Emory Road Subdivision Replat A

City Plan Commission — April 10, 2025

CASE NUMBER/TYPE:	SUSU25-00028 – Resubdivision Combination
CASE MANAGER:	Myrna Aguilar, (915) 212-1584, AguilarMP@elpasotexas.gov
PROPERTY OWNER:	Enrique Escobar
REPRESENTATIVE:	Sitework Engineering LLC
LOCATION:	North of Sunland Park Dr. and West of Doniphan Dr. (District 1)
PROPERTY AREA:	2.24 acres
VESTED RIGHTS STATUS:	Not Vested
PARK FEES:	\$2,740.00
EXCEPTIONS/MODIFICATIONS:	Yes, see following section
ZONING DISTRICT(S):	R-3 (Residential)
RELATED APPLICATIONS:	SUSU22-00097 Emory Road Subdivision
PUBLIC INPUT:	No opposition received as of April 3, 2025

REQUIRED CROSS-SECTION:

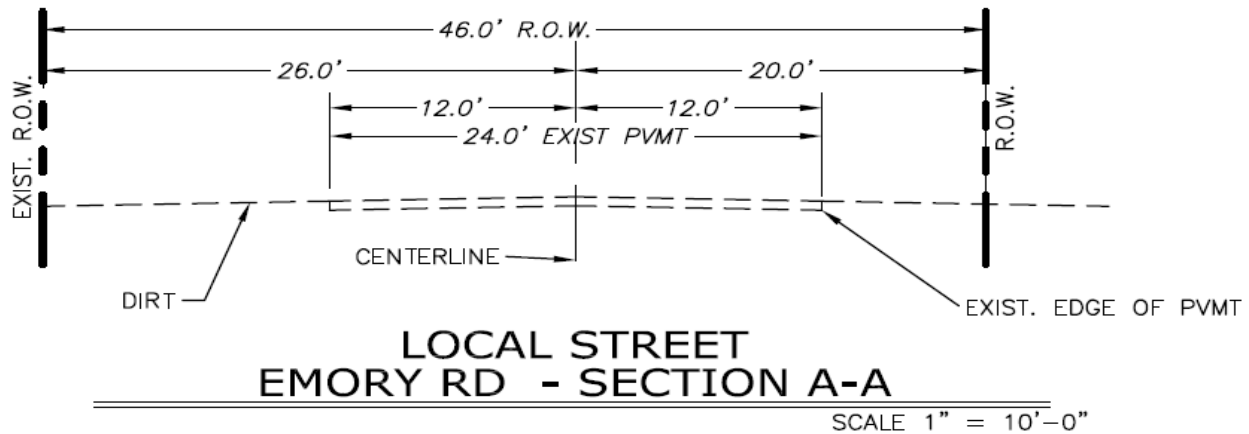
EXCEPTIONS, MODIFICATIONS, OR WAIVER REQUESTS: The applicant is requesting four (4) exceptions pursuant to El Paso City Code Section 19.10.050 (A)(1)(a)- (Roadway participation policies-Improvement of Roads and Utilities Within and or Abutting the Subdivision) and Section 19.23.040 (Lots-Determination and Regulation of Size) of the applicable code. The exceptions include the following:

1. To waive the dedication of 1.5 feet if additional right-of-way along Emory Road.
2. To waive the construction of 2.5 feet of additional roadway along Emory Road.
3. To waive the construction of a 5-foot sidewalk along Emory Road.
4. To allow Panhandle lots exceeding the maximum length of one hundred (100') feet.

EVALUATION OF EXCEPTION REQUEST: The exception request to waive right-of-way improvements meets the following criteria under El Paso City Code 19.10.050(A)(1)(a) – (Roadway Participation Policies— Improvement of Roads and Utilities Within and or Abutting the Subdivision). The section reads as follows:

- a: Fifty per cent of the lots within a quarter mile of the proposed development have already been developed and the existing street improvements are in character with the neighborhood.

EMORY ROAD SUBDIVISION REPLAT A

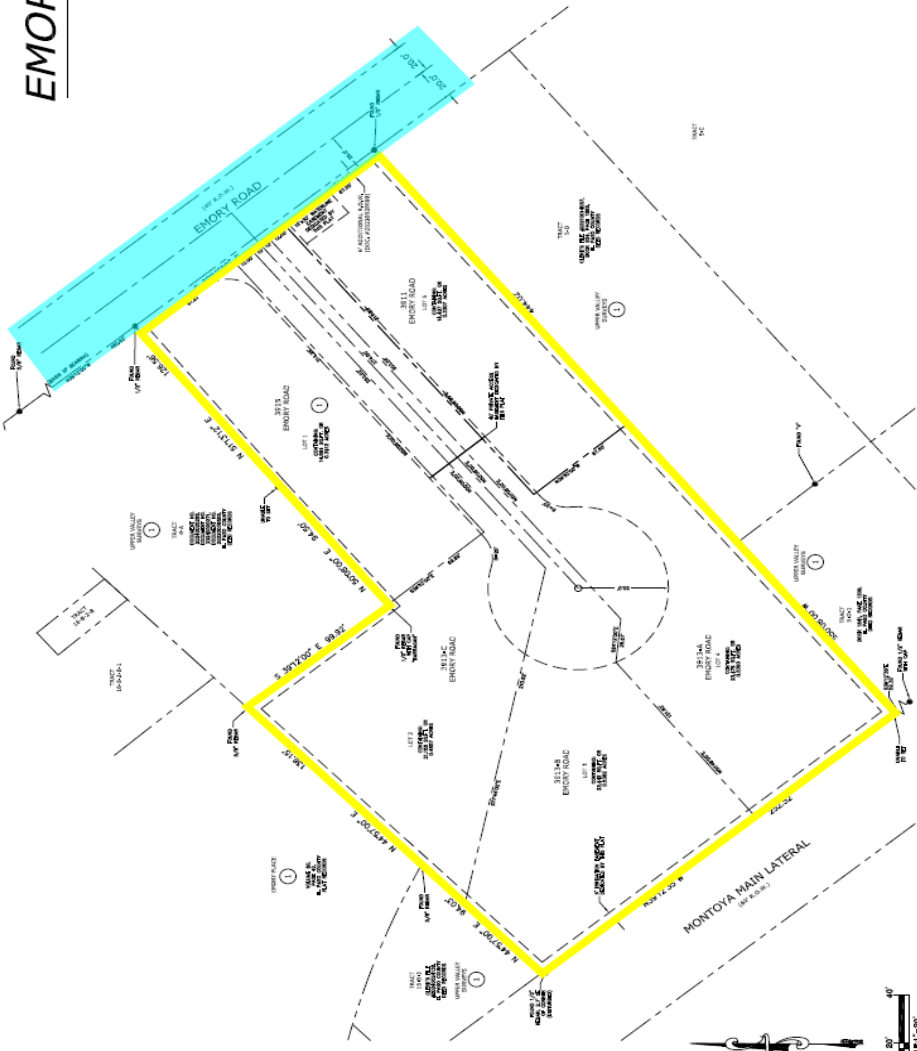
1. Provide print-out of the mathematical closure of the exterior boundary of the subdivision indicating the error of closure.
2. The subdivision is in the flood zone area, and Elevation Certificates shall be required for each property at the time of building permits plans and slab.
3. Add a general note to both the preliminary and final plat sheets: "The retention of all storm-water runoff discharge volume is required within this subdivision's limits in compliance with all provisions of (Muni-Code 19.19.010A, **SDM**, and DDM Section 11.1)."
4. Dimension lot 1 corner radius.

Remove the word “**Waterline**” from the 15x30 foot PSB easement dedicated by this plat.

Please add a 10' wide easement along the private access drive for access to the proposed lots for future development.
